Submissions to Environmental  
Assessment

**Proposed Gas Turbine Facility, Munmorah, Scenic Drive, Doyalson, Wyong LGA**

MAJOR PROJECT PROPOSAL:  
PROPOSED MUNMORAH GAS TURBINE FACILITY

Application Ref No: (05\_0195)  
Location: Part Lot 61 DP1065038 Doyalson Wyong NSW  
Proponent: Delta Electricity  
Approval Authority: Minister for Planning

Figure 1

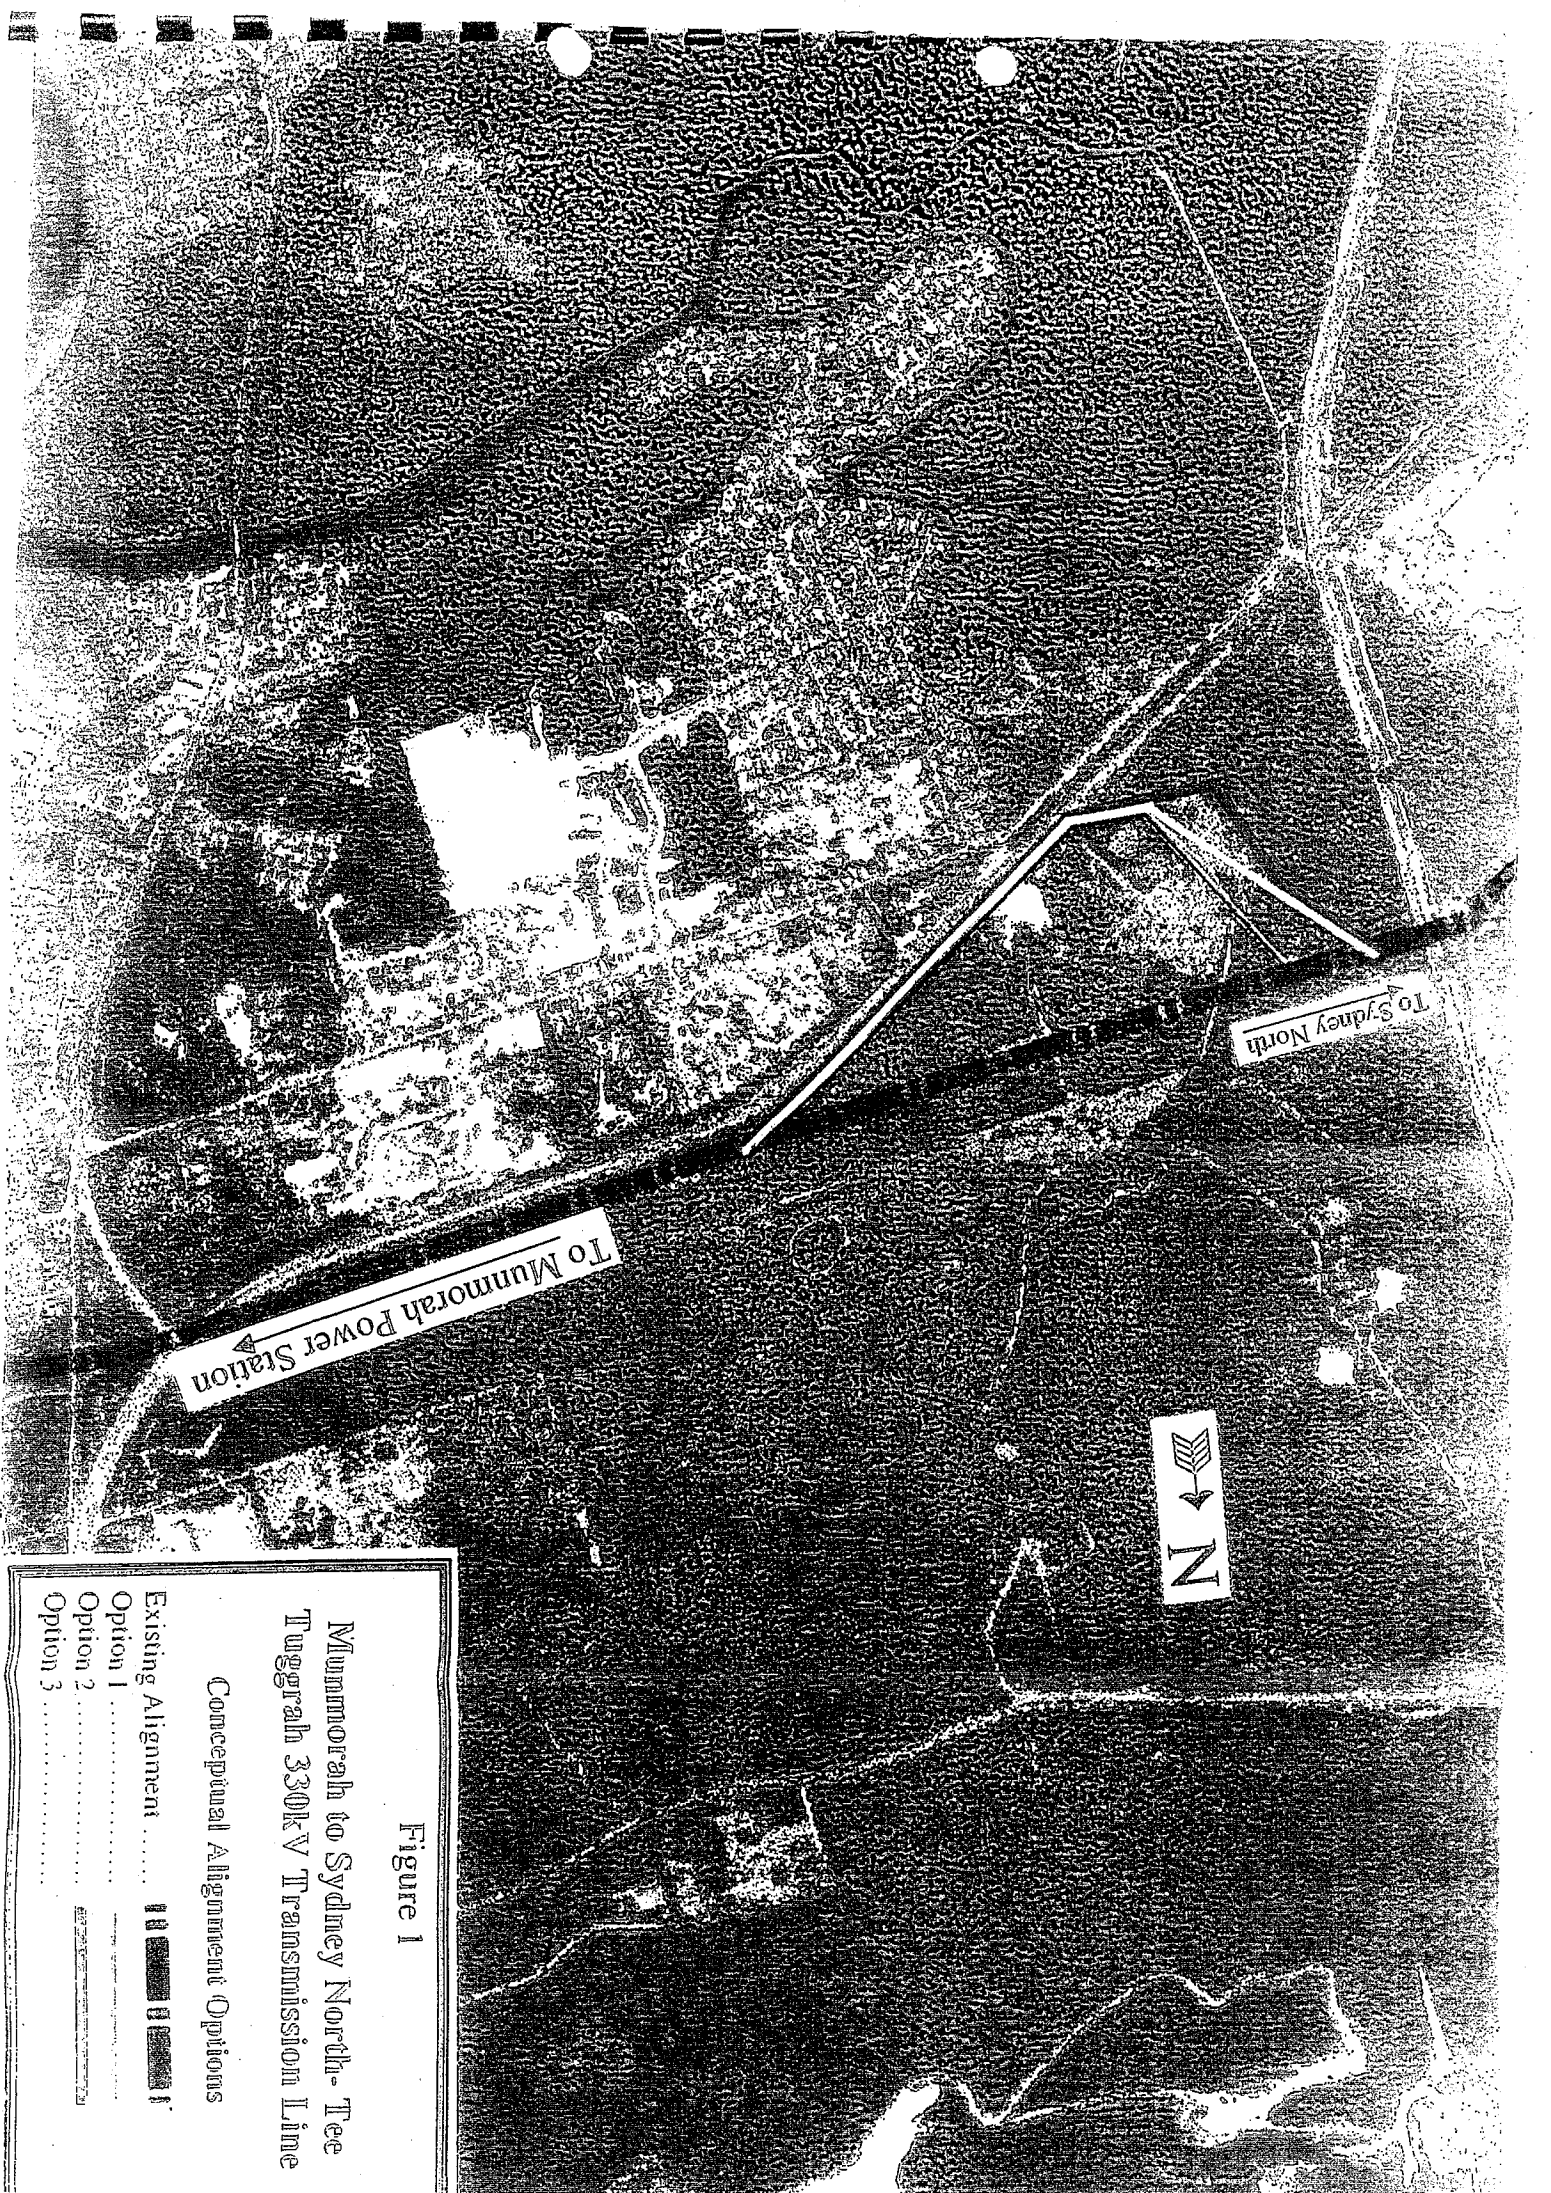
TransGrid has identified three possible conceptual alignments and these are shown on Figure 1.

The three possible alignments are shown on figure 1 and are described below:

It is considered that Option 2 is the best of the three options developed. It is not the cheapest of the options but it does give the client a larger area to develop, also it does avoid the three building (houses or sheds) shown on figure 2.
